Submission on HVO North and South continuation project

Matt Saunders, Jack Thrower, Rod Campbell
September 2025

The Australia Institute welcomes the opportunity to make a submission on the revised proposal to extend the Hunter Valley Operations (HVO) North and South Open Cut mines (referred to as the project).

Figure 1: Coal price assumptions used by EY in the economic assessment

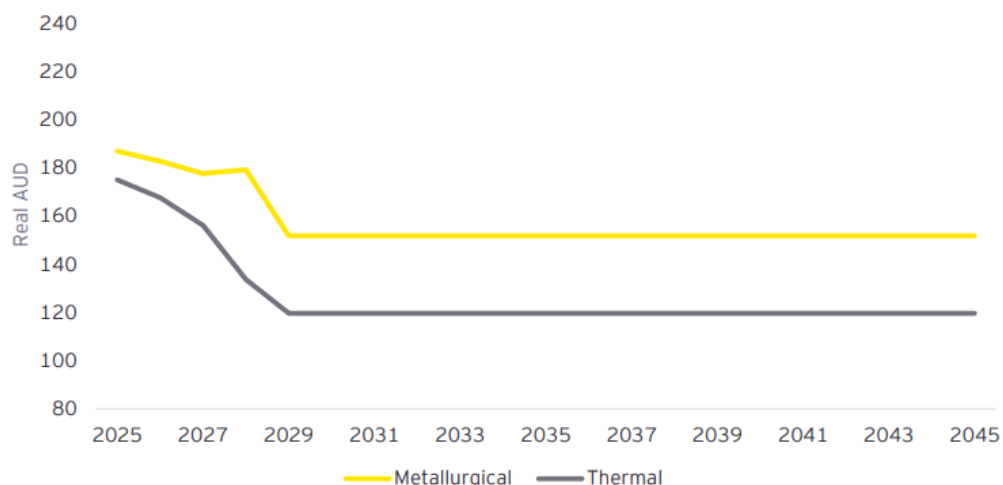
The coal prices used in the economic assessment, reproduced in Figure 1, suggests EY and mine owners are assuming a coal market that is incompatible with a habitable planet. The coal prices for the project are assumed to continue the recent downward trend that followed the spike in global energy prices with the Russian invasion of Ukraine, to conveniently level out and remain constant from when the project reaches full production, around 2029, until 2045. Quite simply, stable coal prices do not align with a coal market outlook where the global demand for coal is falling.

While there is some sensitivity analysis around the coal price assumptions, the *25% lower coal price scenario*¹⁴ keeps the assumed coal prices within pre-Russian invasion historical averages. This shows that this sensitivity scenario is *also* not reflective of a coal market outlook that is on a path to phasing out coal by the 2040s.
